ADDENDUM No. 1

ITB No. 4467

Barton Dam Hydroturbine: 10-Year Inspection and Overhaul DUE DATE: Tuesday, January 24, 2017 at 10:00 A.M. (local time)

M-101 7 of 7 0

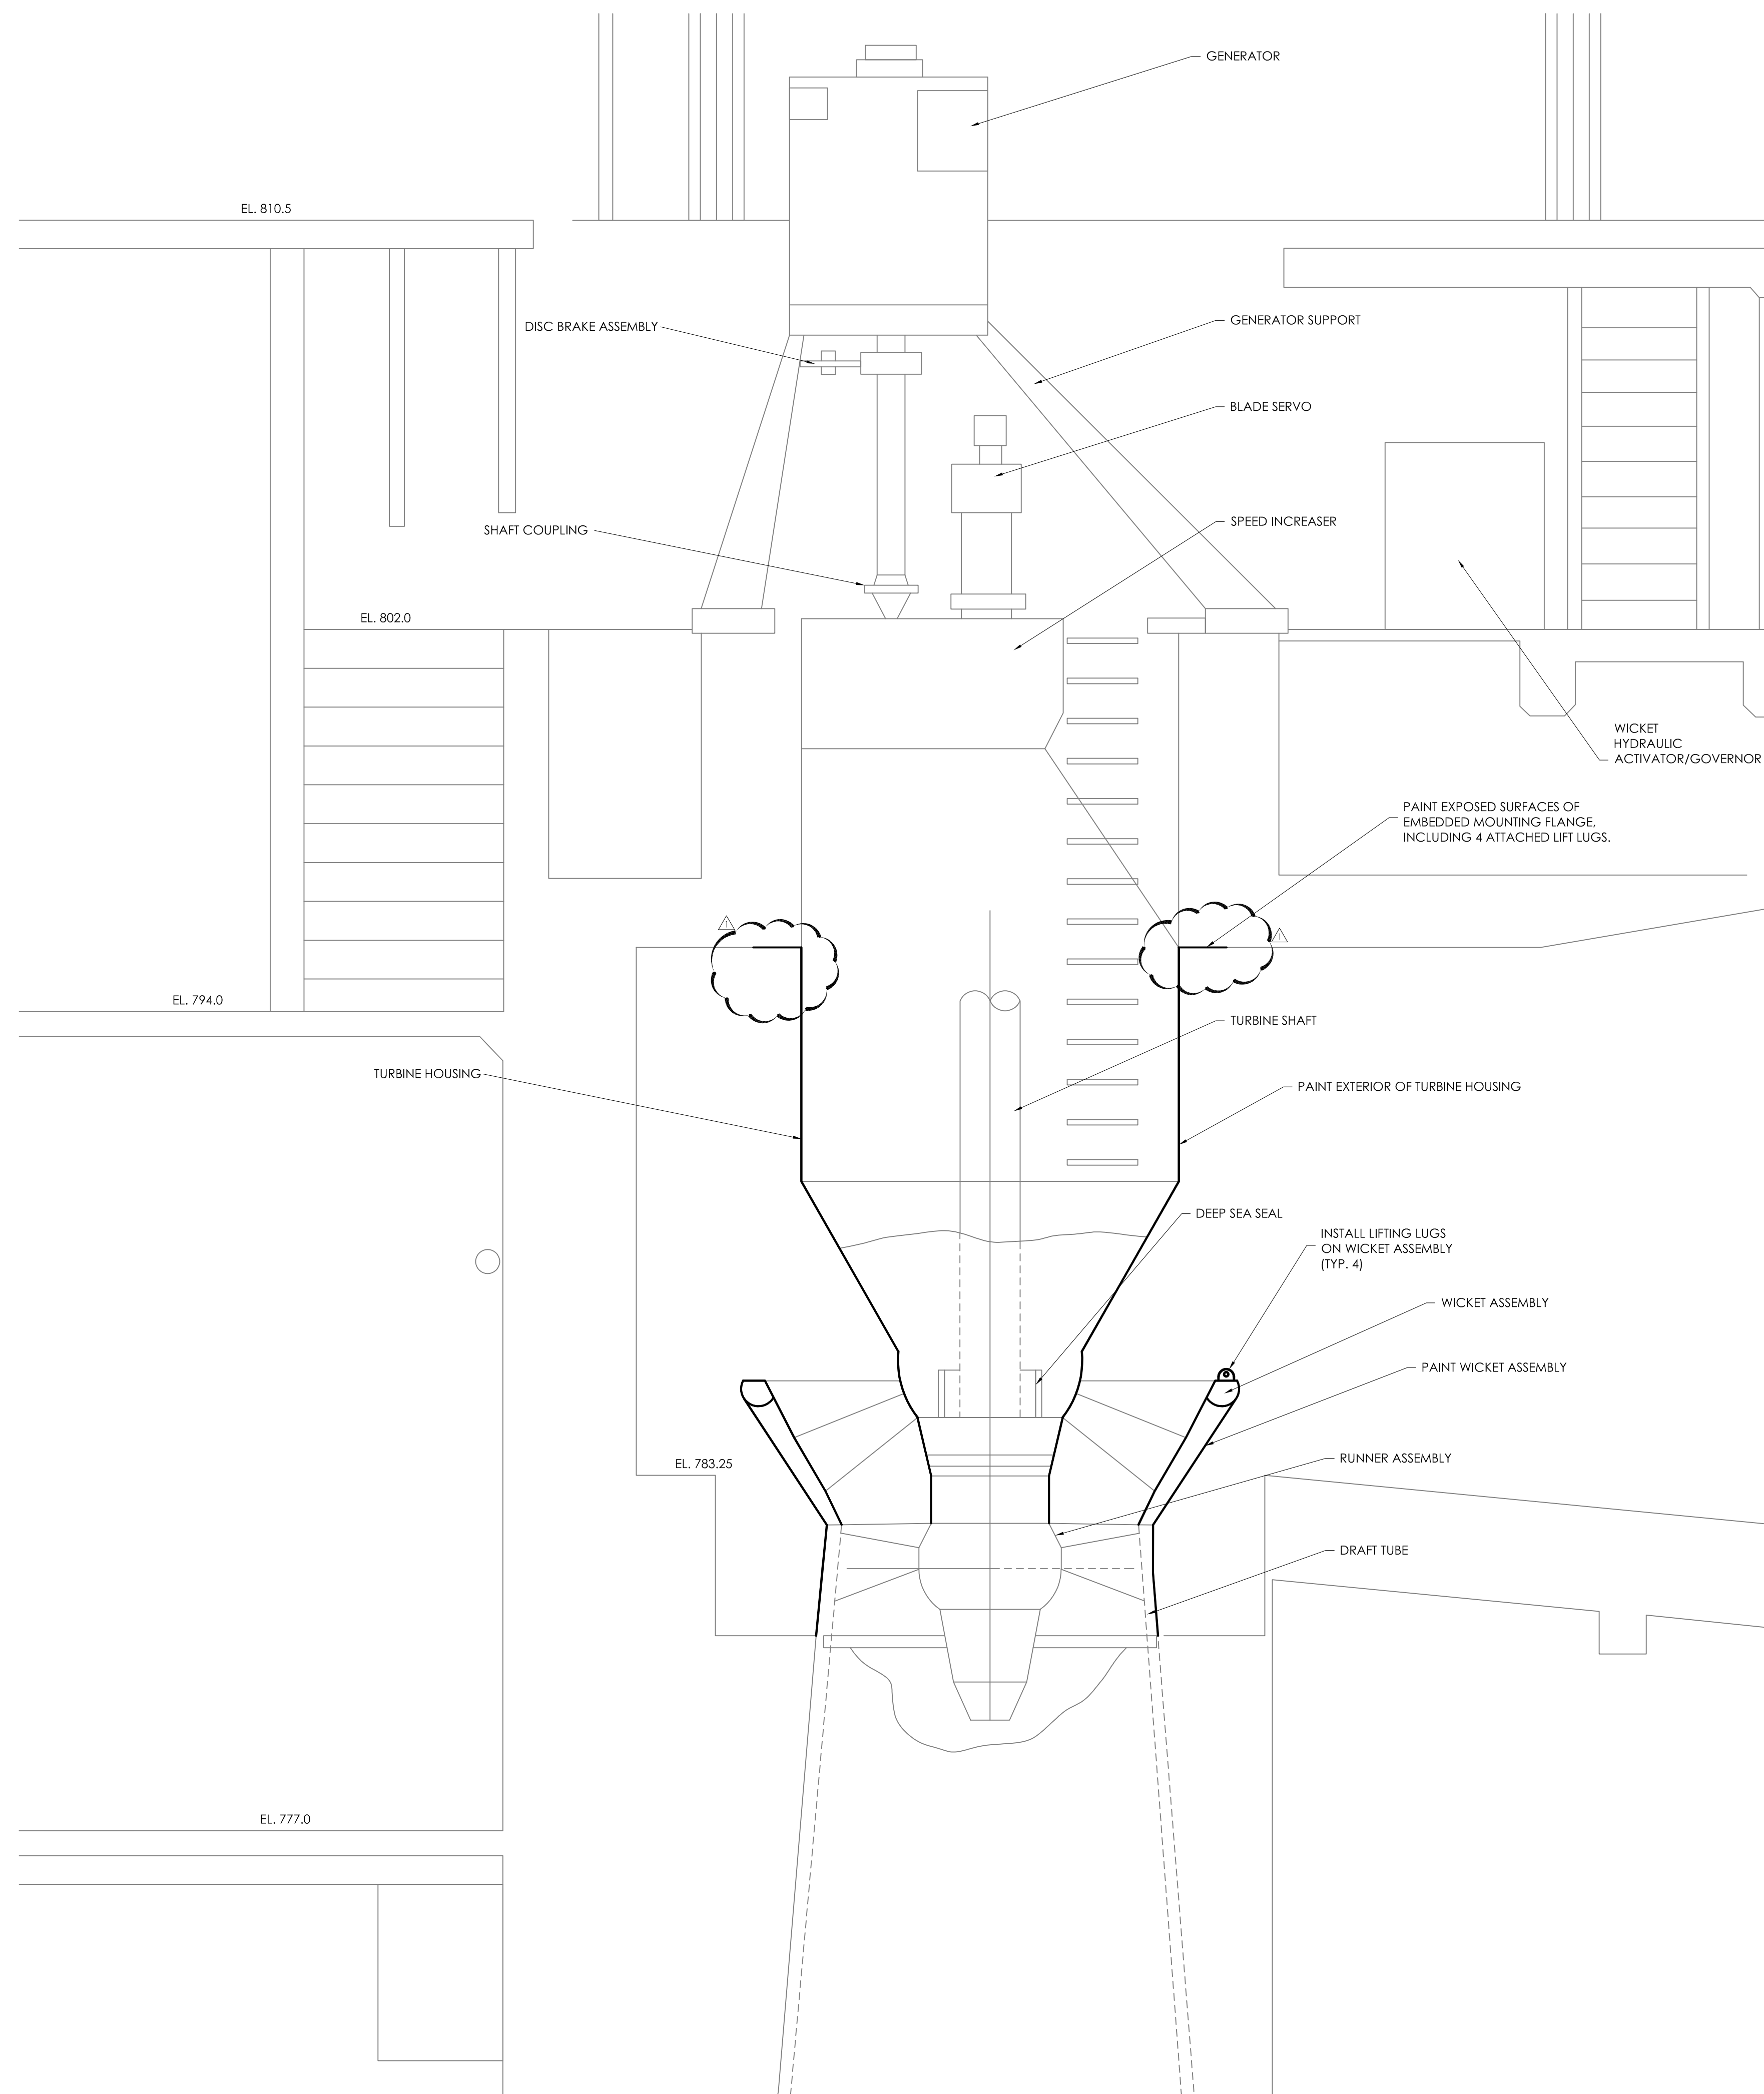
Section/Page(s)	Change
BF-2	Correct Allowance unit. Add Item 10 "Allowance for Procurement of Additional Parts by Contractor". NOTE: As part of the bid submittal, replace the original BF-2 page with the BF-2 page attached to this addendum.
01000-5	Correct Allowance unit. Add Method of Measurement and Payment for "Allowance for Procurement of Additional Parts by Contractor".
S-101	Revise demolition/reconstruction limits for wall as shown. Note additional field conditions.
M-101	Show additional area to receive paint – wheel pit upper mounting flange for turbine housing.
